PACKAGE 3.4
REACTOR COOLANT SYSTEM (RCS)
PART A

PRAIRIE ISLAND NUCLEAR GENERATING PLANT
UNITS 1 AND 2

Improved Technical Specifications
Conversion Submittal

LICENSE AMENDMENT REQUEST DATED December 11, 2000

Figure TS.3.1-3 8.4.17-1 (Page 1 of 1)

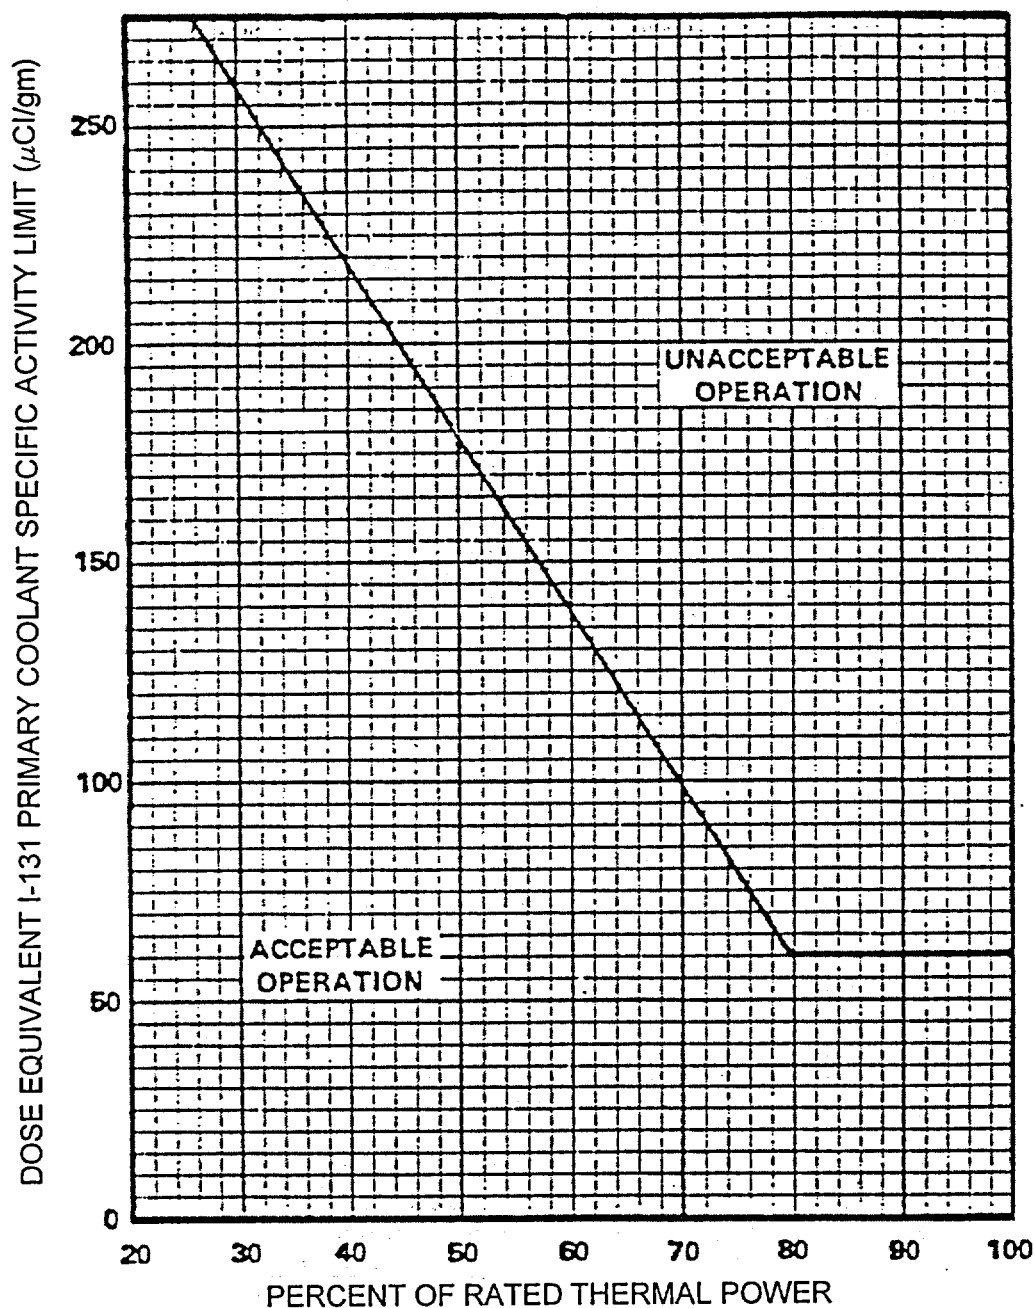
- a. With the specific activity of the primary coolant greater than 1.0 microcurie per gram DOSE EQUIVALENT I-131, ~~verify once per 4 hours to be within the acceptable region of Figure TS.3.1-3,~~ for more than 48 hours during one continuous time interval or exceeding the limit line shown on Figure TS.3.1-3,

L3.4-82

~~Next pages are Figure TS.3.1-3 and TS.3.1-12.~~

NSHD Category	Change Number 3.4-	Discussion of Change
	80	Not used.
M	81	CTS 3.1.D.2.a. In accordance with the guidance of NUREG-1431, verification that the limits of Figure TS.3.1-3 (ITS Figure 3.4.17-1) are met shall be performed every 4 hours. Since CTS do not specify a time frequency, this is a more restrictive change. This change is acceptable since it will assure that the limits are met on a timely basis and it does not introduce any unsafe plant operating conditions.
L	82	CTS 3.1.C.3 and Table 4.1-2B, Item 4a. CTS RCS specific activity limits when the RCS temperature is below 500°F and above cold shutdown have not been retained. The purpose of Specification 3.4.17 is to limit SGTR releases to a small fraction of 10CFR100 limits. This change is acceptable because below 500°F the release of radioactivity in the event of a SGTR is unlikely since the saturation pressure of the reactor coolant is below the lift pressure settings of the main stream safety valves. Since this change would not retain CTS requirements it is less restrictive on plant operations. This change is consistent with the guidance of NUREG-1431.
